KMR.CDD.LyQ.1912-1914.02

ORDERS UNDER SECTION 96 (2) OF ACT III OF 1910.

With reference to his application dated 24/1/14 1914.
Mr. Mahomed Lurich is informed
that the plan submitted by him for building a house
on plot No. 24, 28, 30 Survey Sheet K1
situate in Mulla Street Agri
Quarter, is approved, and permission to build in accordance therewith is
granted. The building to be erected subject to the Byelaws and Rules of the
Municipality.

—SHOWING THE BUILDING ON PLOTS N^{os} 27, 28 & 30-KI—

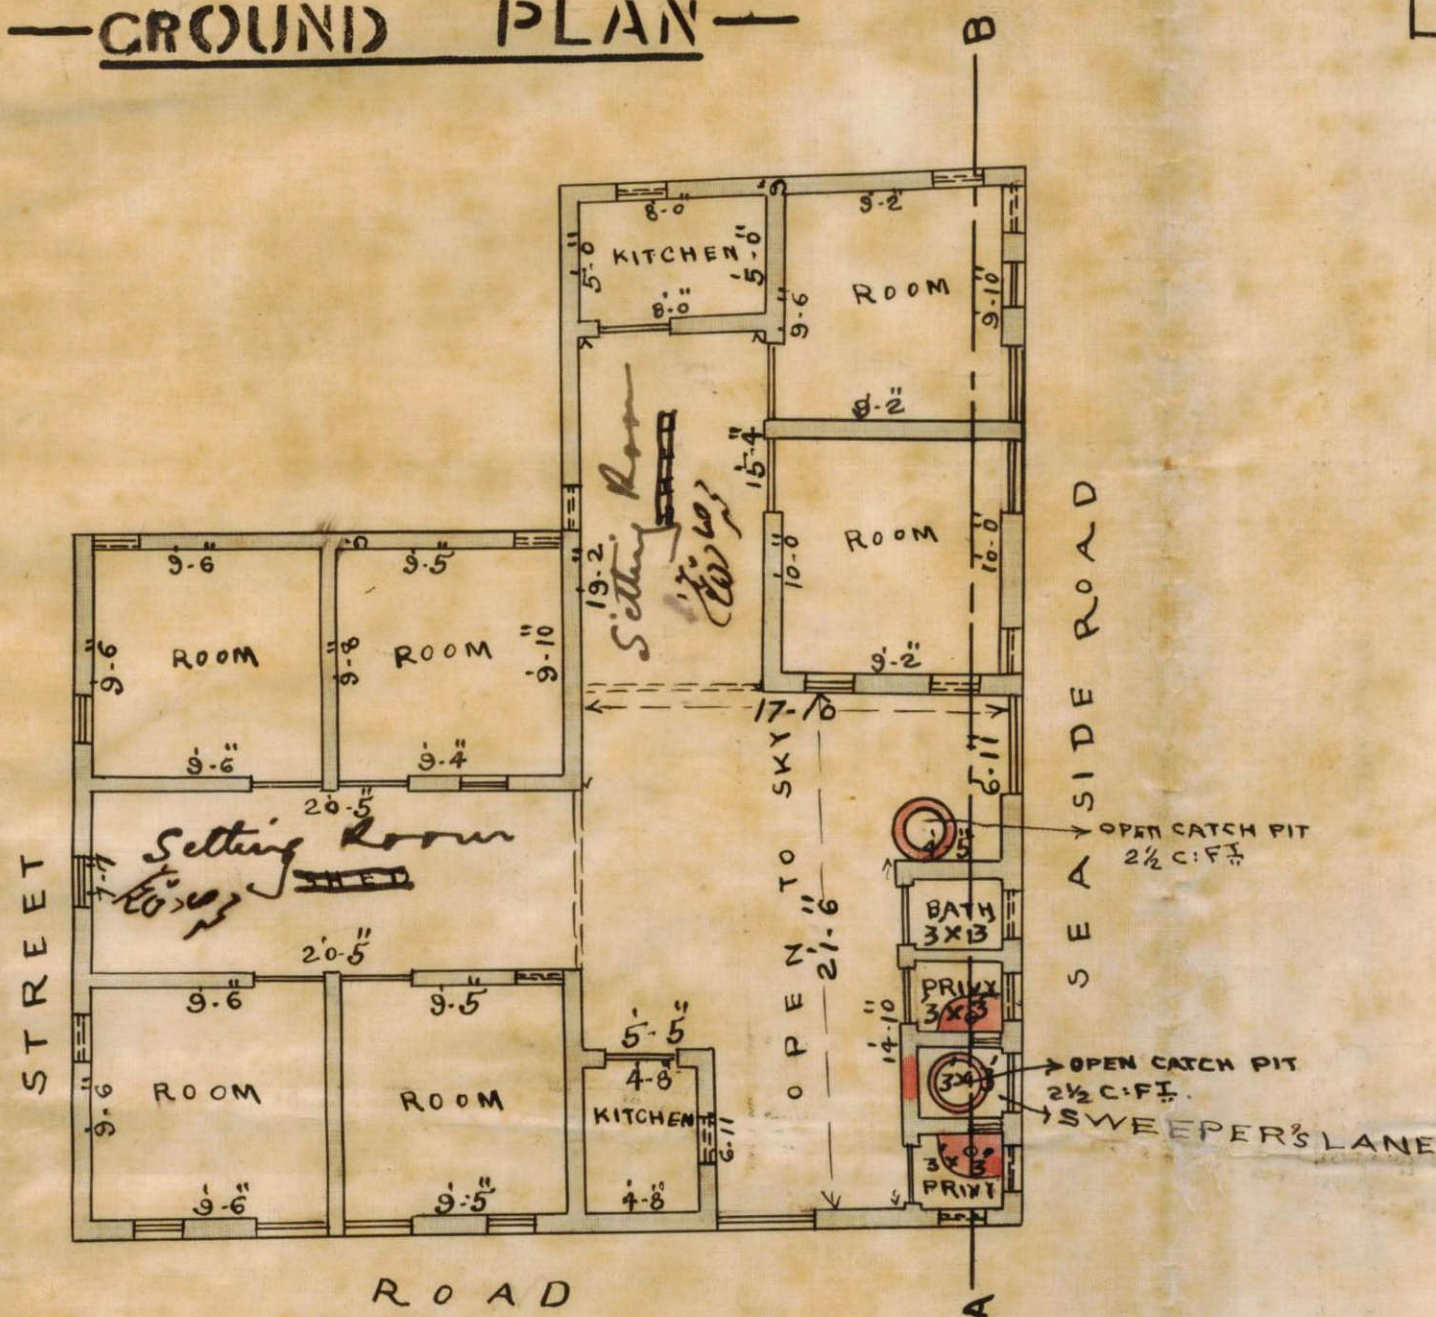
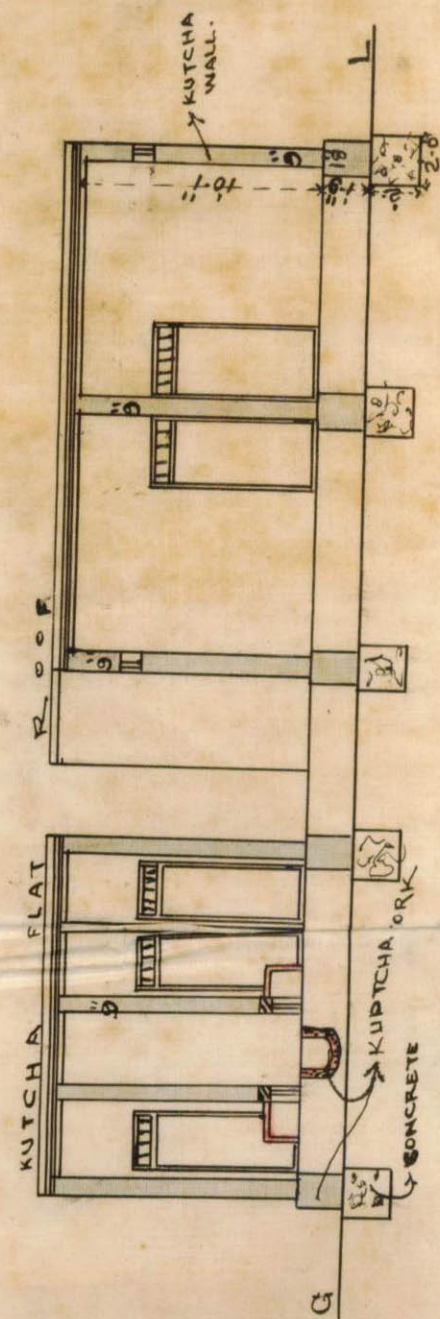
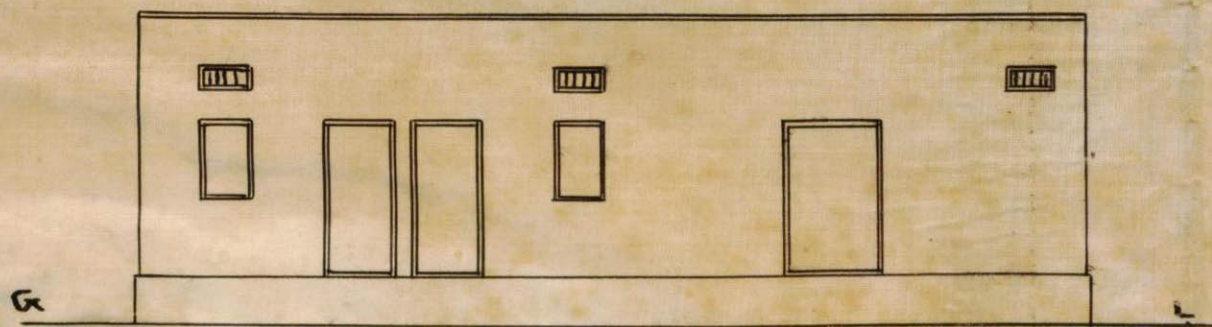
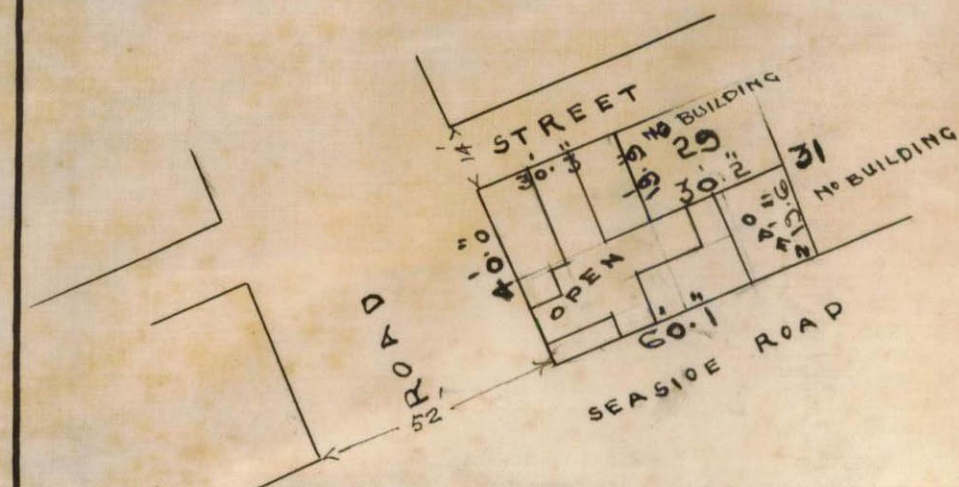
With reference to his application dated 17th ultimo, with a plan for building house on plot No.27, X-28, & 30, K-1, Lyari quarter Mr. Mahomed Siddik is informed that the sheds shown on the plan must be deleted and an open space left in the compound, when his request for a pass will be considered.

There should be no sheds
erected in the compound. 10
They must be substituted by
open space, to allow free
air & light to the living
rooms

With reference to his application dated 27th ultimo, with a plan for building house on plots Nos.27,28 & 30,K-1, Lyari quarter Mr. Mahomed Sidick is requested to show separate catchpits for bath water. The plan is herewith returned with a request that ~~the~~ the materials of which the house is built ~~be~~ be shown, it should be coloured and properly dimensioned.

L. Surveyor Return the plan as it is not shown of what material the house is built. The note on the plan says new work of red but there is very little red on the plan. It should be coloured & dimensioned. Refer the Architect to up mens no. 3662 dated 26th June

With reference to his application dated 8th instant, with a plan for building a house on plots Nos. 27, 28 & 30, K-1, Lyari quarter Mowlvi Mahomed Sidick wd Haji Abdulla is informed, roof ventilation is not approved. He must have some open space and through ventilation.

With reference to his application dated 7th instant with a plan for building rooms on plots Nos. 27, 28 and 30, K-1, Lyari quarter, Mr. Mahomed Sidick wd Haji Abdulla is requested to show any means of through ventilation to the rooms facing the lane on the east as no provision for ventilation is shown on the plan.

Rooms facing east have no ventilation

as shown on the plan
Roof ventilation is not
approved. The applicant must leave
open space & show the
through ventilation

With reference to your letter no. 200
dated 1st Oct 1913 I herewith send
your honor the amended plan as
drafted. I showed the plan to your
honor personally and you have
allowed permission for the same
verbally.

With reference to your letter no. 7005 dated 1st Oct 1913 I herewith send your honor the ammended plan as directed. I showed the plan to your honor personally and you have allowed permission for the same verbally.

I beg to report that

there is no objection

now to grant permission

as a separate catchment
